**BOARD OF ZONING APPEALS
CITY OF PRAIRIE VILLAGE
TUESDAY, JULY 11, 2023
7700 MISSION ROAD
COUNCIL CHAMBERS
6:30 P.M.**

BZA2023-02 Variance of required front setback for garage addition
2216 W. 71st Terrace
Zoning: R-1B
Applicant: Gary and Cindy Wainscott

STAFF REPORT

Application: BZA 2023-02; PC 2023-107

1 SITE PLAN

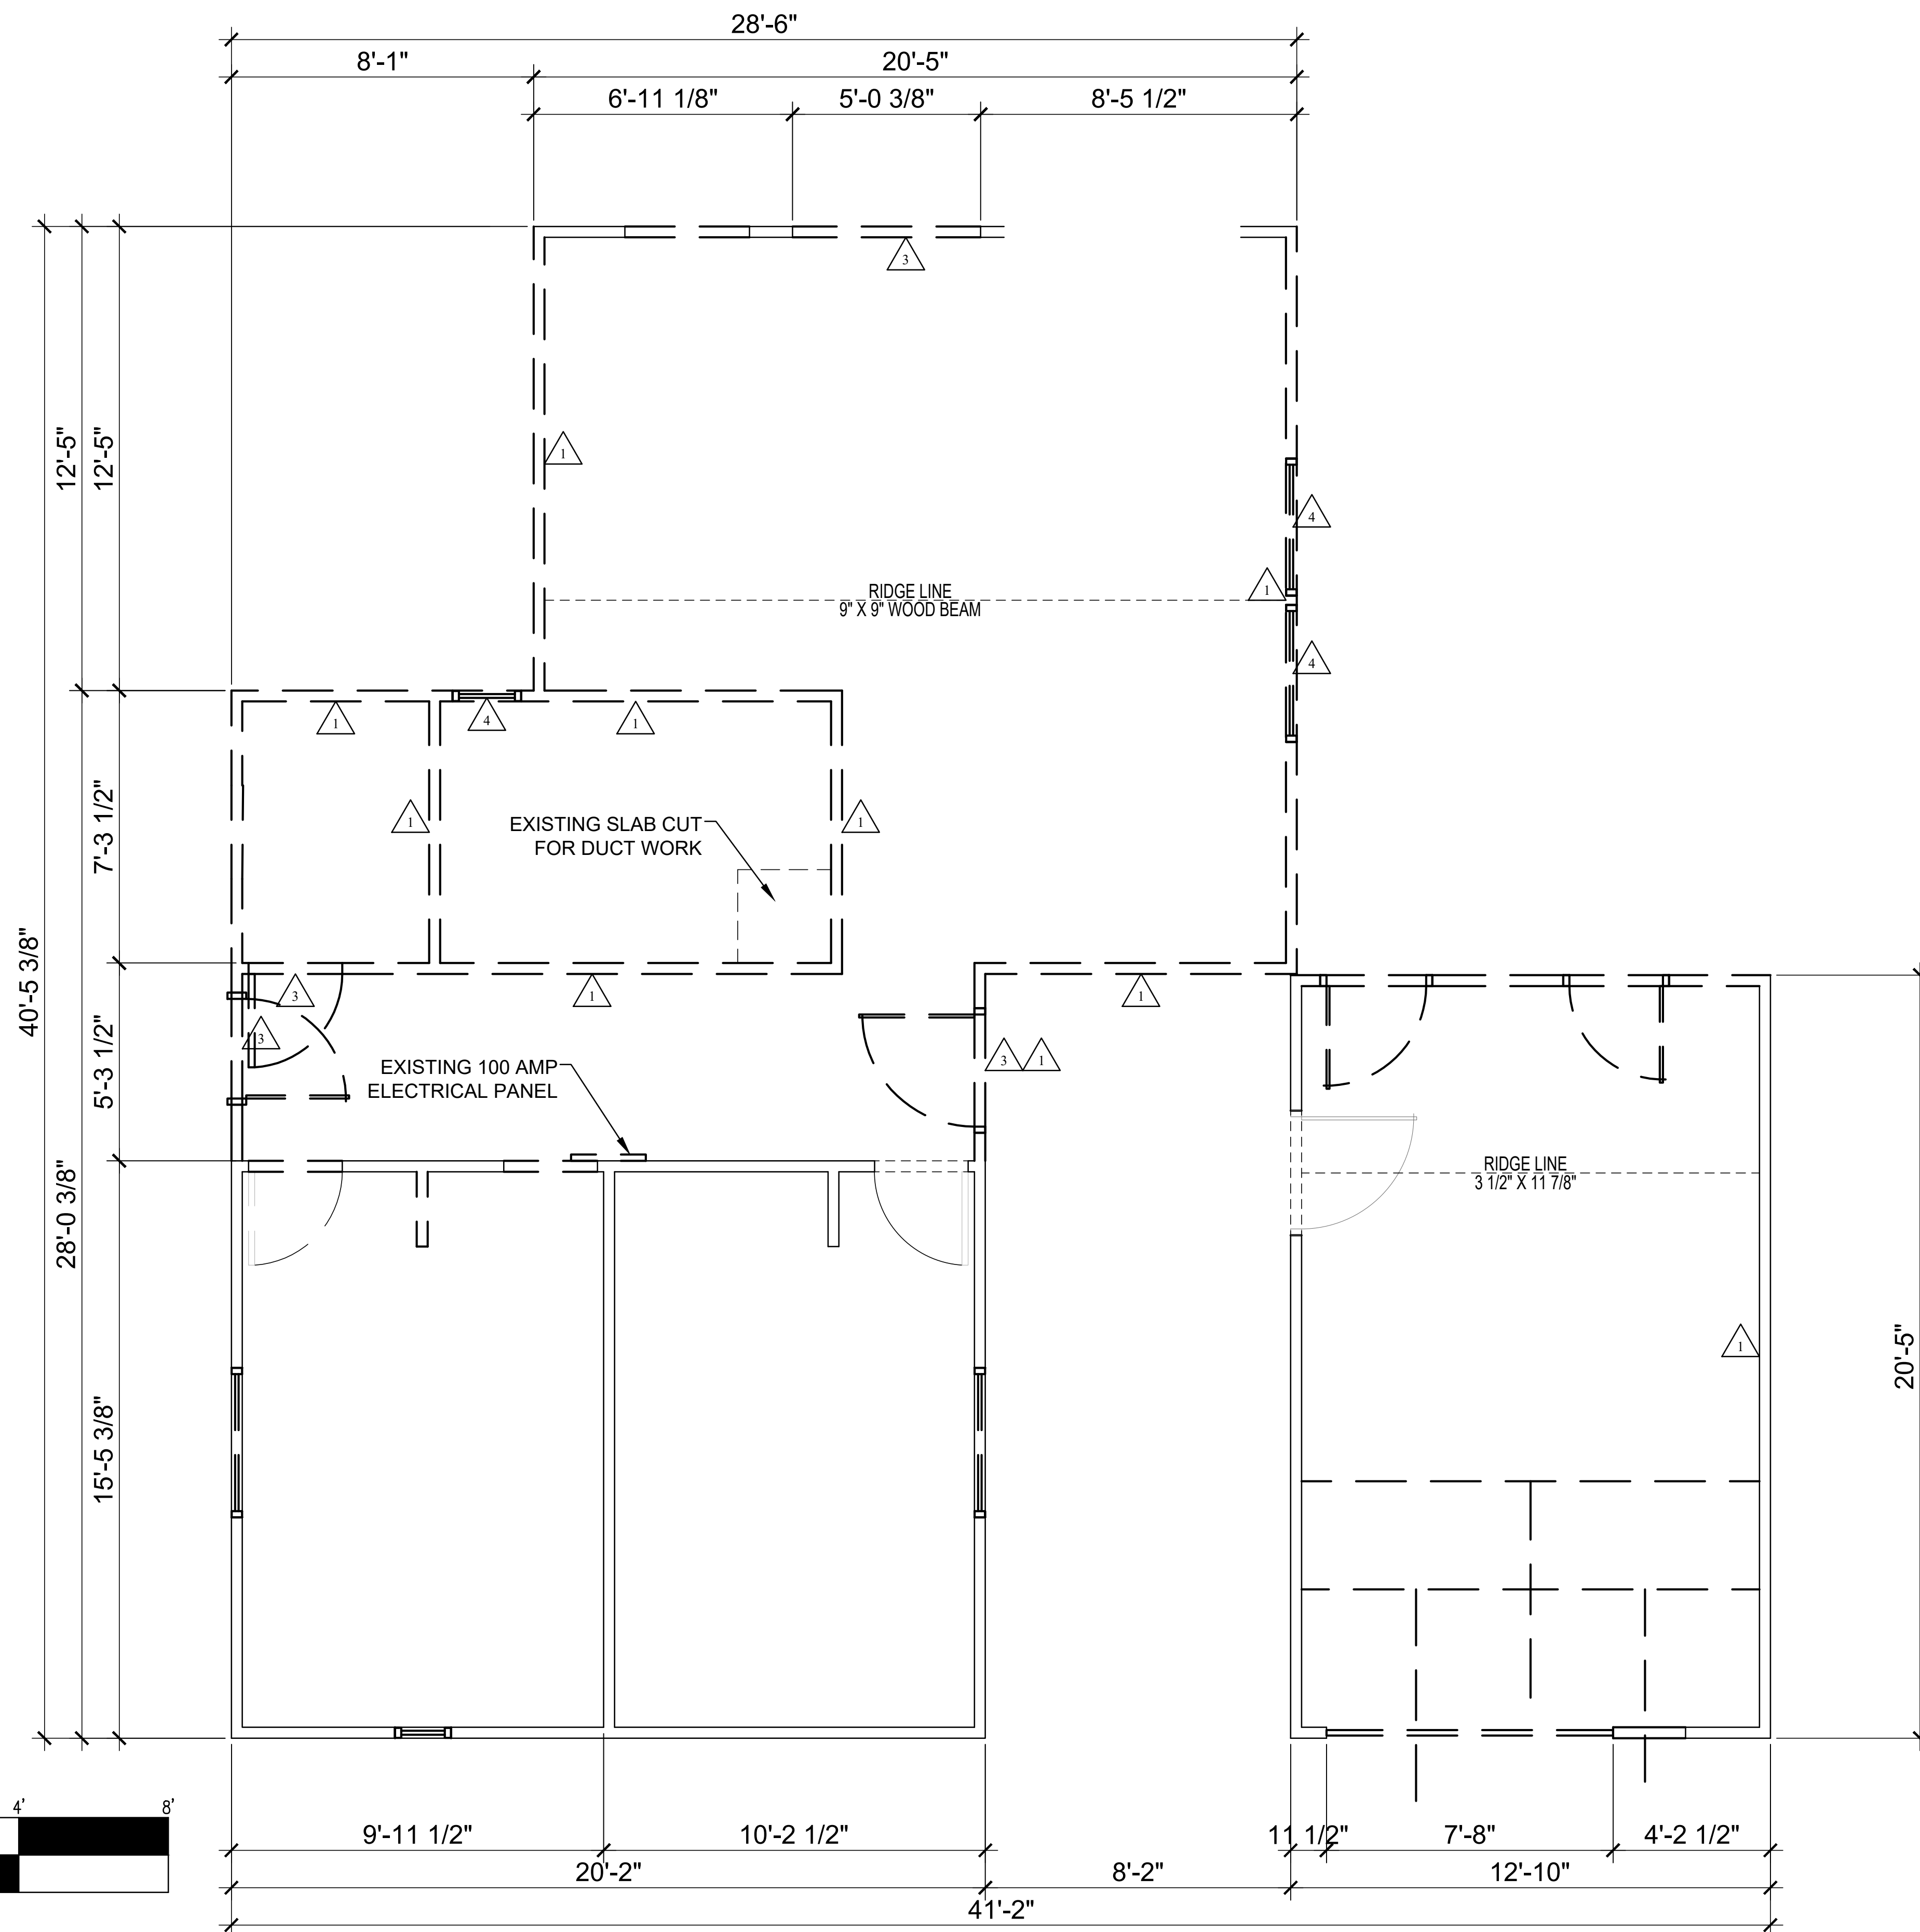
The applicant is requesting a variance from Section 19.08.015 to allow garage to be built 23.42 feet from the front setback, rather than the required 30 feet. This lot also includes a platted front building line of 35 feet. The existing building is located at 23.42 feet, and it is not clear that there was any record of a variance or platted building line modification. AIMS records indicate the building was constructed in 1956, which predates the zoning ordinance. The plat was recorded in 1924, but the provision for modifying the front building line through city processes was not in place at the time the structure was built. The building is at this location due to a drainage culvert that crosses the property, entering the lot on the west side approximately 20 feet from the front lot line, going north for approximately 60 feet and then going east across the lot near the midpoint of the property, 80 feet from the front line. This results in a small buildable area towards the front portion of the lot, and a rear yard section across the drainage culvert on the back 45 feet of the lot. The property is zoned R-1A. The development standards require a front setback that is at least 30 feet from the front lot line. [\[19.06.015\]](#).

The applicant has placed a garage addition on the east side of the building along the existing front building line; however, this does not comply with the required front setback. The plat also includes a platted front building line of 35 feet. Typically, modification of the front building line is done through an exception granted by the Planning Commission. However, since this request would also be in excess of the zone district setback, a variance is required and the lessor included criteria for a building line modification will be assumed met through the variance review and criteria.

1. That the variance be granted only to the extent shown with the submitted application, sufficient improve the existing structure at its current location and not encroach further into the front setback.
2. The variance, if approved, be recorded with the County Register of Deeds within 1 year of approval.

2 SOUTH (FRONT) ELEVATION
 1/4" = 1'-0"

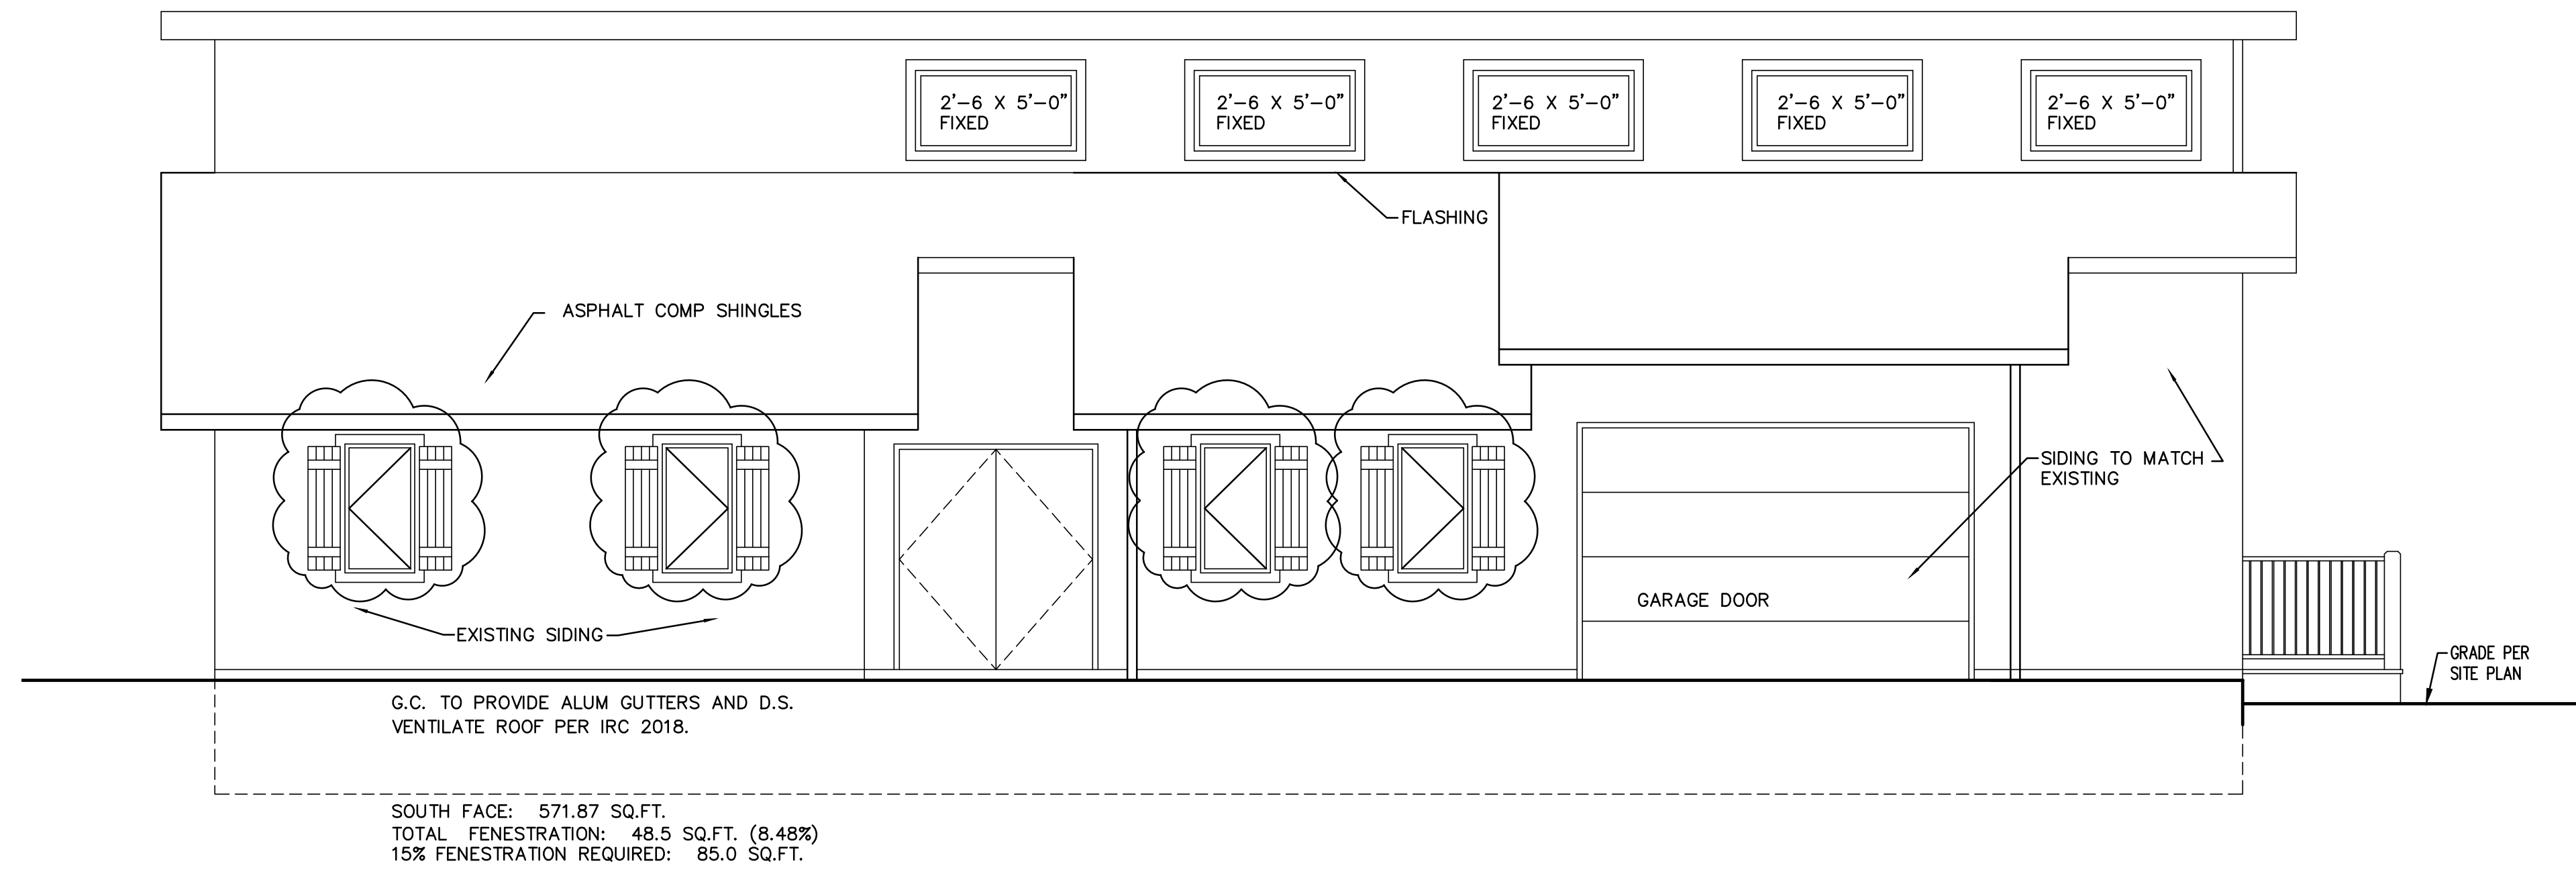
In this case, the four windows on the front elevation account for approximately 7.35 % of the wall planes (or a 10.35% if the applicant counted up to the 3% limit for trim and ornamentation associated with the windows or doors). These wall planes include the front-facing garage, but the garage door is specifically excluded for counting towards the transparency. Other transparency on this elevation occurs with the front door and with upper-level windows including in the wall supporting the staggered pitched roof. However, these wall planes are more than 12 feet back from the front building line, and neither the wall plane nor the windows count towards the requirement. The elevation has varied massing due to the step back of one of the garage bays, gables at two different depths, and a larger remainder of the elevation more than 12 feet beyond the forward part.

The existing building does not provide transparency or meet the design standards. The proposed elevations associated with the remodel are bringing this building further towards compliance with the standards. The existing building and proposed remodel have a unique architectural character that is appropriate for this lot and context. Further, the recessed entry court and upper-level windows (which do not count towards meeting the fenestration standard) contribute to the front elevation as a whole becoming closer to the intent of the standards than the current building.

Staff recommends approval of the exception to the neighborhood design standards (window and entrance requirements on the front elevation) subject to concurrence of the Planning Commission on all criteria, and limited to the plans submitted.
